Addendum 5 of REQUEST FOR PROPOSAL

Shasta Regional Transportation Agency

**Battery Electric Vehicle Procurement for
Salmon Runner and North Valley Feeder
Procurement No. 2019-01**

January 28, 2019

Passenger door 1: construction

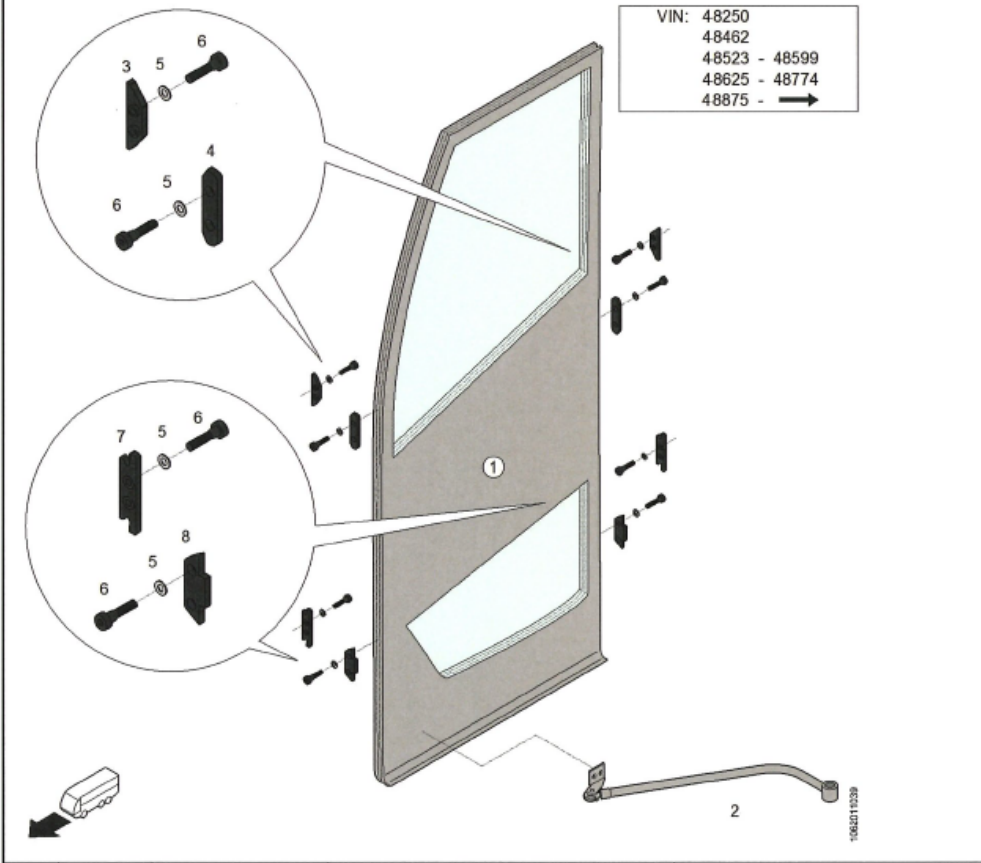
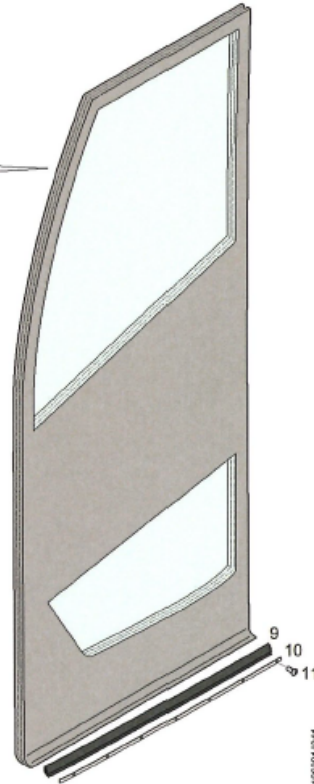
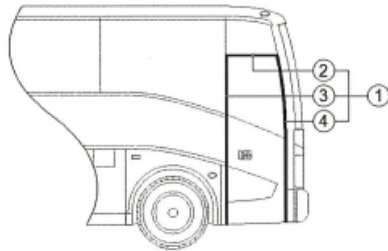
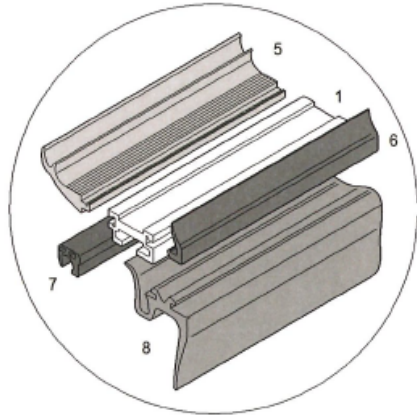
Request #: 01	
Proposer: ABC Bus, Inc.	
RFP Section: TS 80 Passenger Doors	
Page: 142 & 143	
<p>Questions/clarification or approved equal:</p> <p>Would you accept an air operated out-swinging thin profile design entrance door of 1 panel featuring a thin seal sensitive edge on door with built up weather stripping on the frame in front axle on RHS of coach with exterior electrical metal (stainless steel) operation knob including outside key lock and additional grab handle on the entrance door mechanism (see attached description).</p>	
Agency action:	<input checked="" type="checkbox"/> Approved <input type="checkbox"/> Denied <input type="checkbox"/> See addendum <input type="checkbox"/> See response below
Agency response:
